STATE OF WASHINGTON
DEPARTMENT OF ECOLOGY

June 18, 2018

Re: Opinion pursuant to WAC 173-340-515(5) on Proposed Interim Action for the following Hazardous Waste Site:

- **Name:** Northwest Plating
- **Address:** 825 South Dakota Street, WA 98108
- **Facility/Site No.:** 2231
- **VCP No.:** NW2769
- **Cleanup Site ID No.:** 1361

FIGURE 6
GEOLOGIC CROSS SECTION A-A'

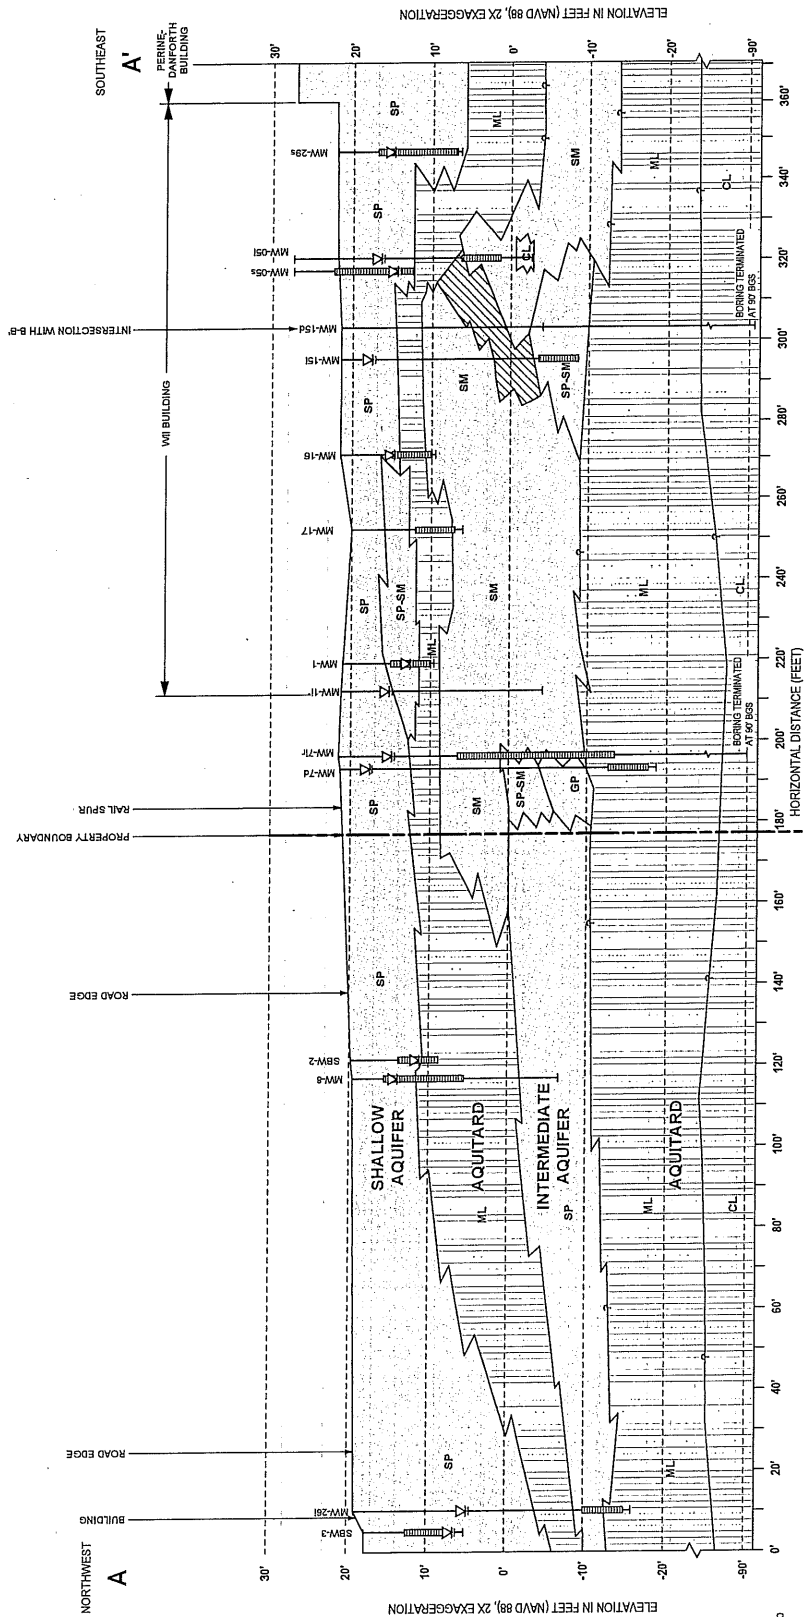
- Figure 6: Monitoring wells MW-26s, MW-7s, MW-15s need to be added to the cross-section. Also, MW-8s is incorrectly labeled as MW-8. Please add the symbol for 'screened interval' to the legend. Contaminant concentrations in both the shallow and intermediate aquifers should be shown on the figure.

FIGURE 7

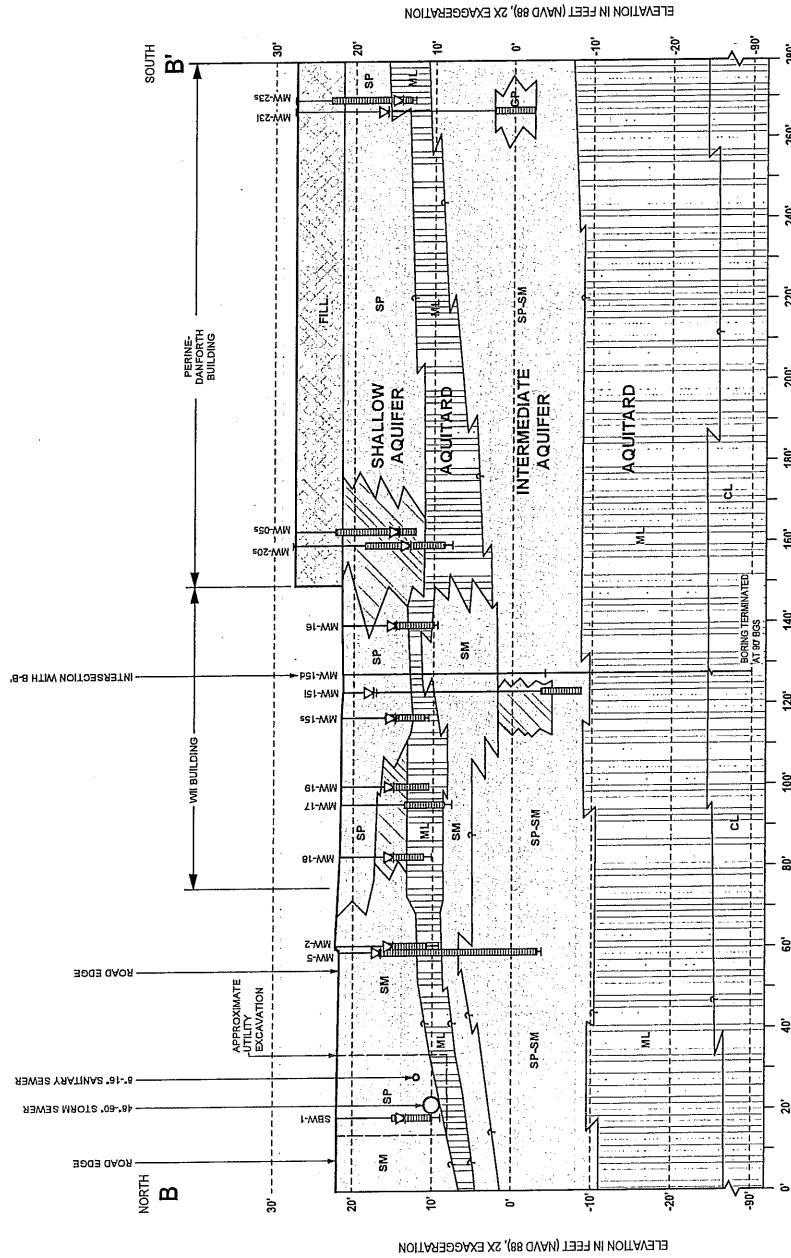
- Figure 7: Monitoring wells MW-5i and MW-20i should also be shown on the figure. Please add the symbol for screened interval to the legend. Contaminant concentrations in both aquifers should be shown on the figure.

FIGURE 23
SHALLOW GROUNDWATER TCE ISOCONTOURS FOR
DECEMBER 2015 (IN µg/L)

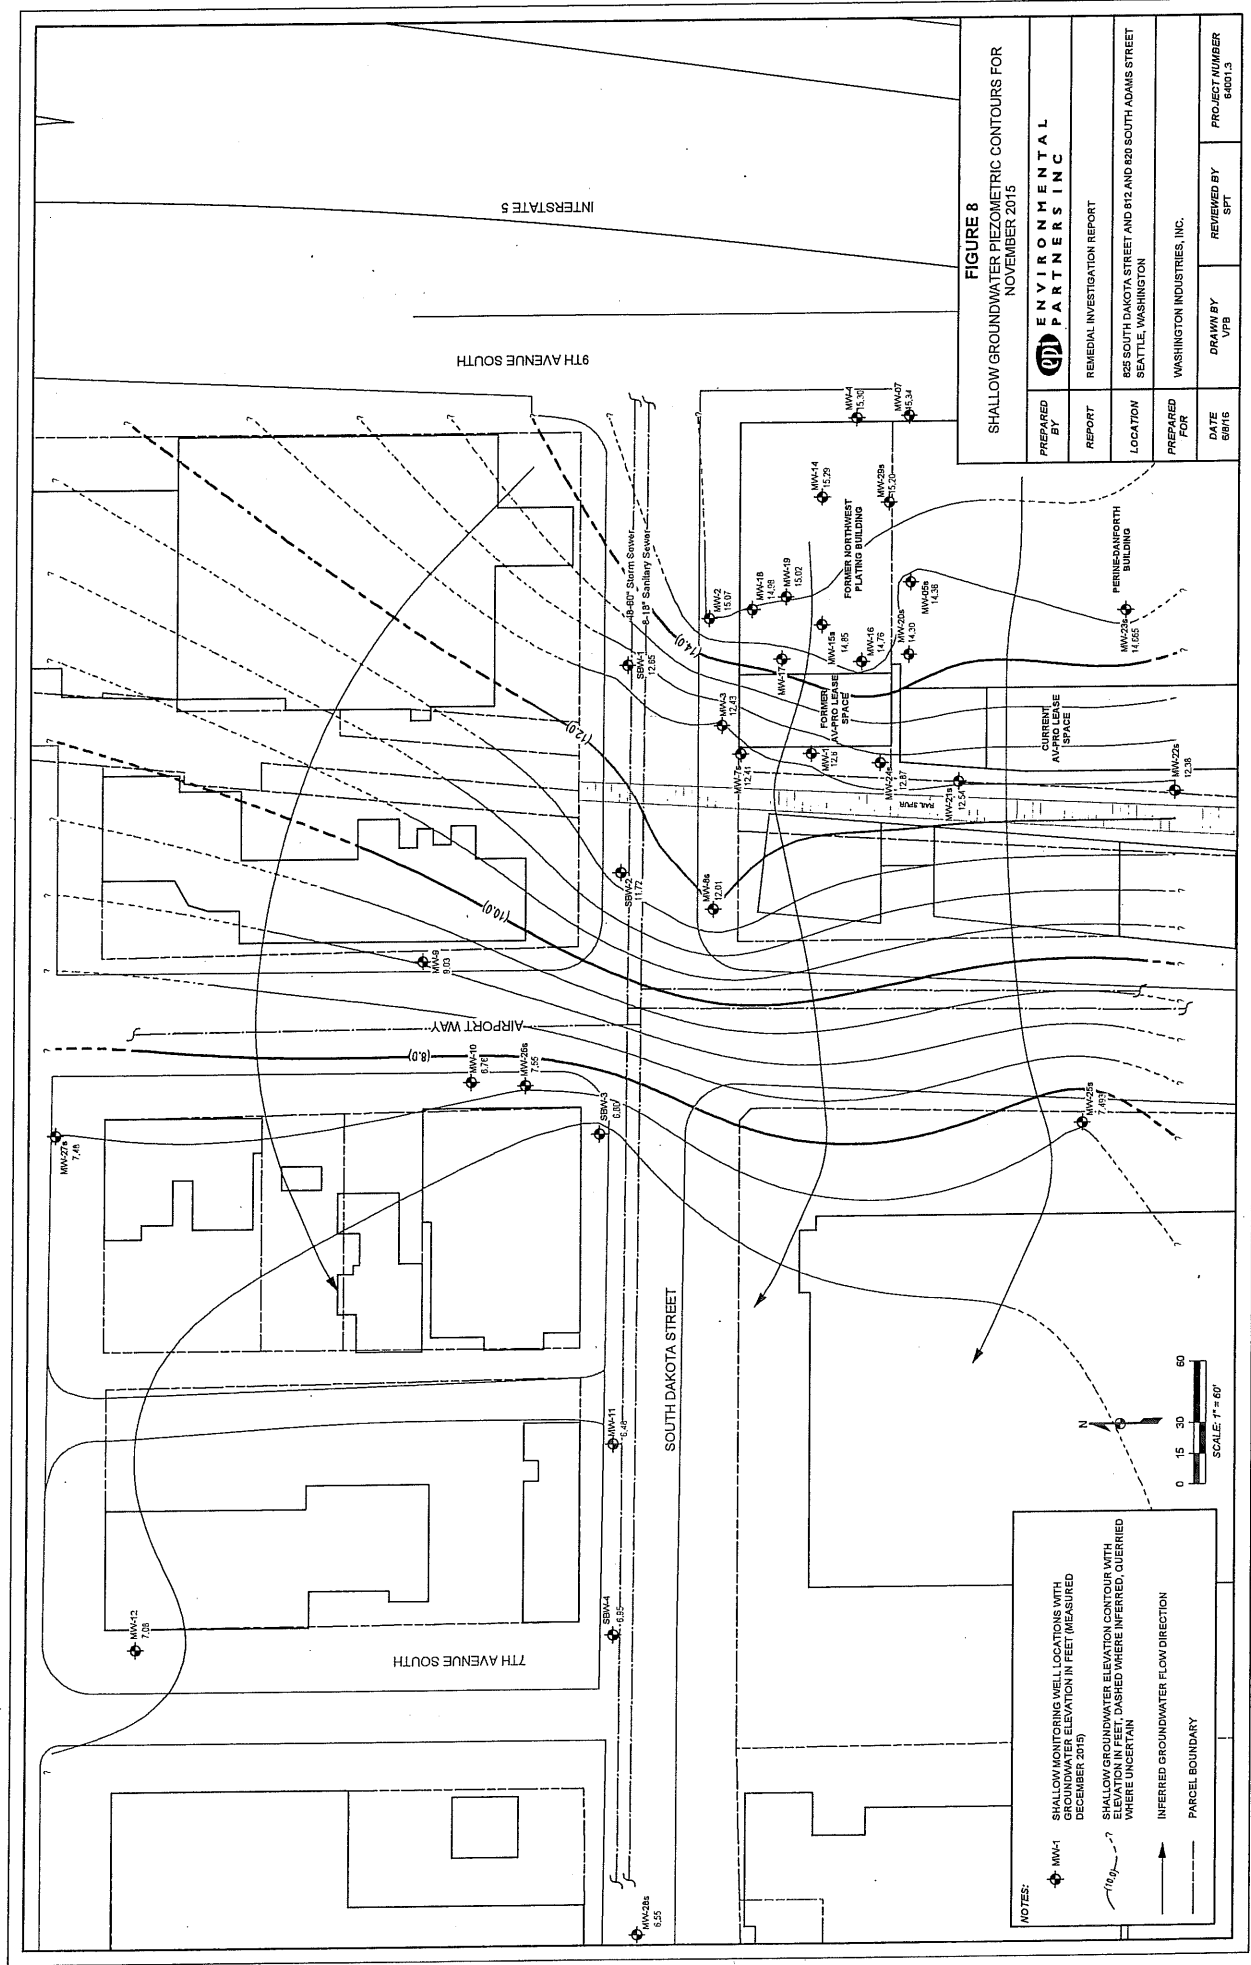
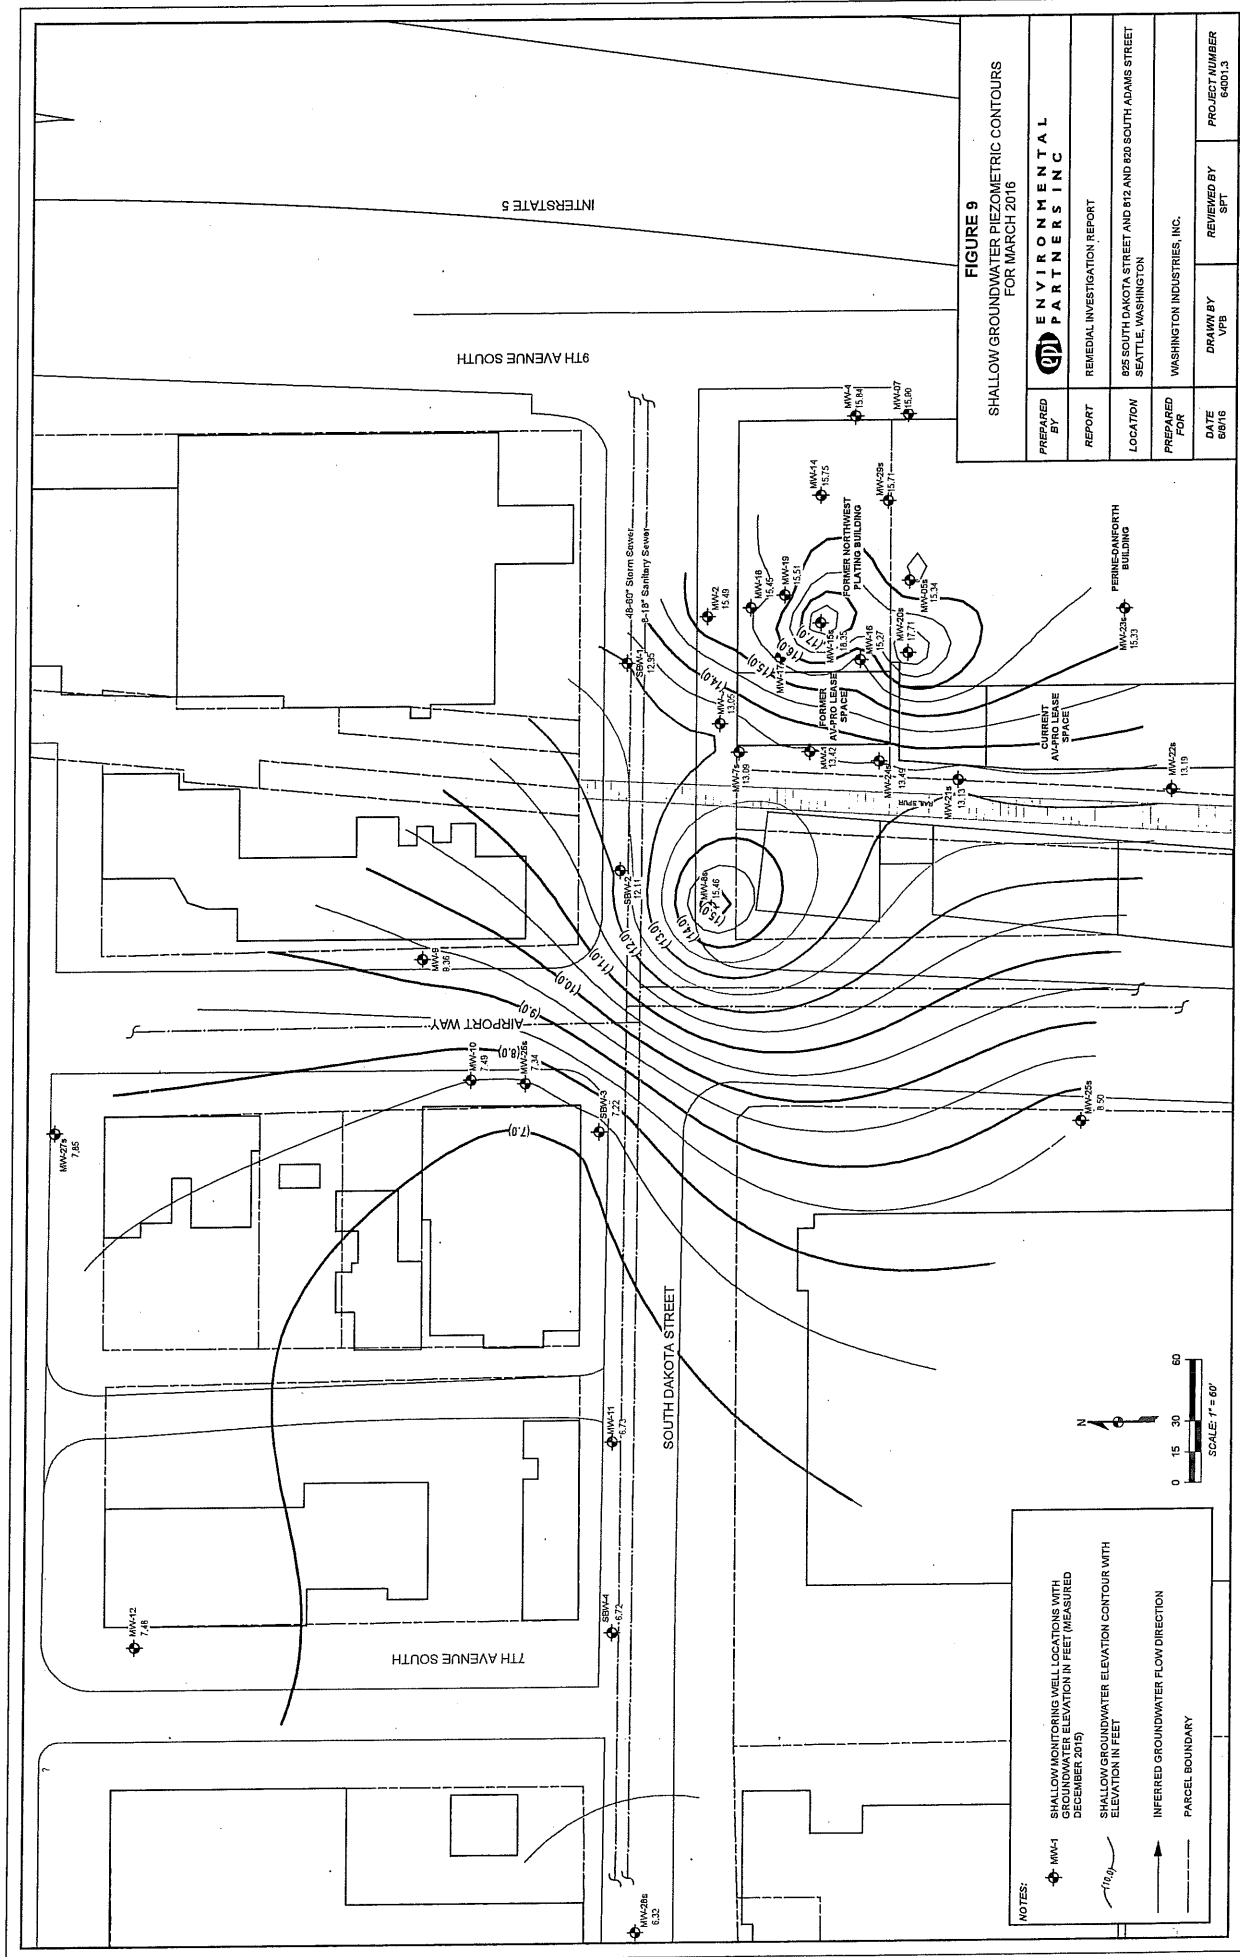
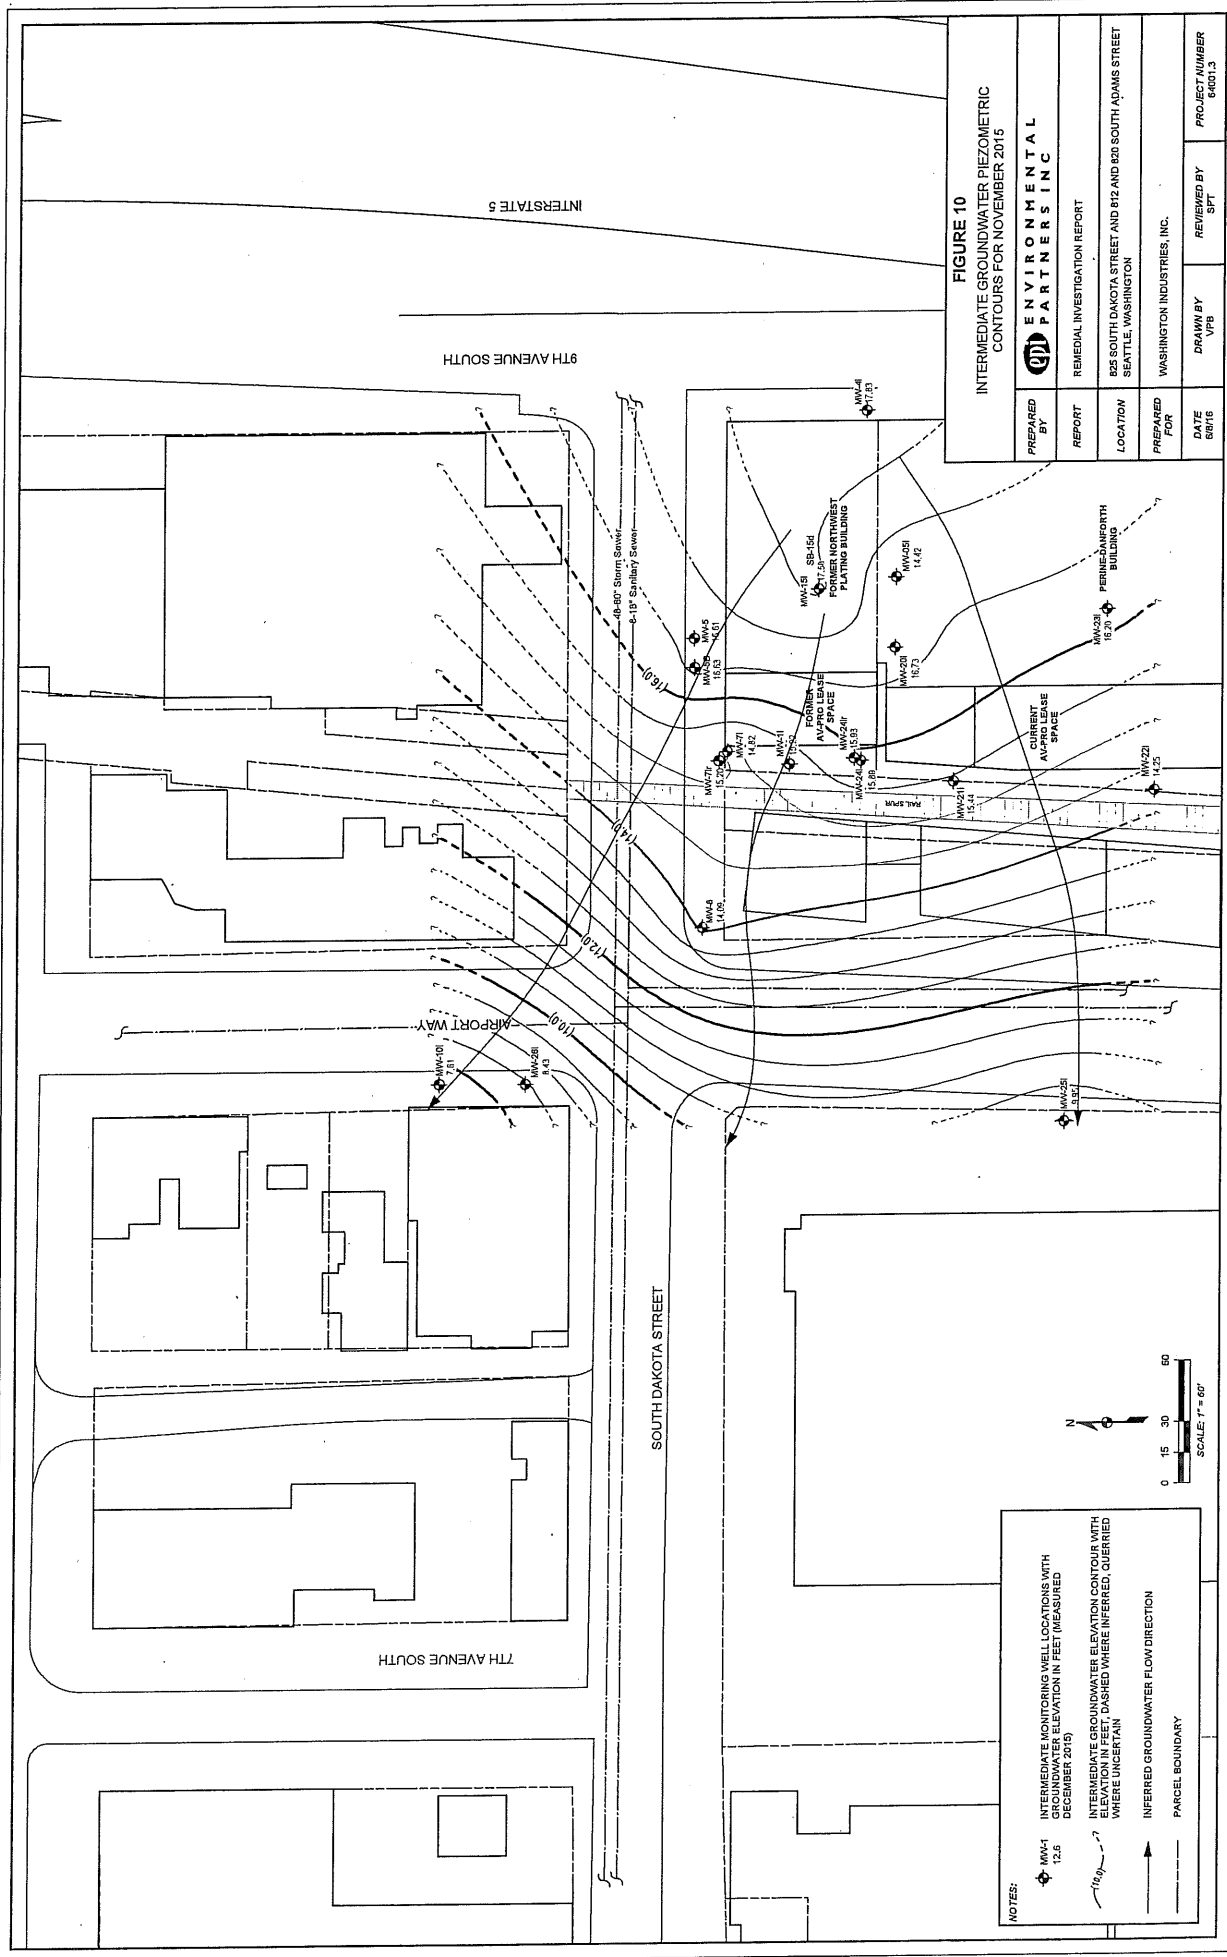
- Figures 18 through 22: Please include TCE data collected on the Perine parcel in the iso-concentration contouring.
- Figures 23 through 25: Please use the Method A cleanup level for TCE in ground

water to draw the TCE plume. Please also add figures showing impacts to the intermediate aquifer on different dates, including current data.
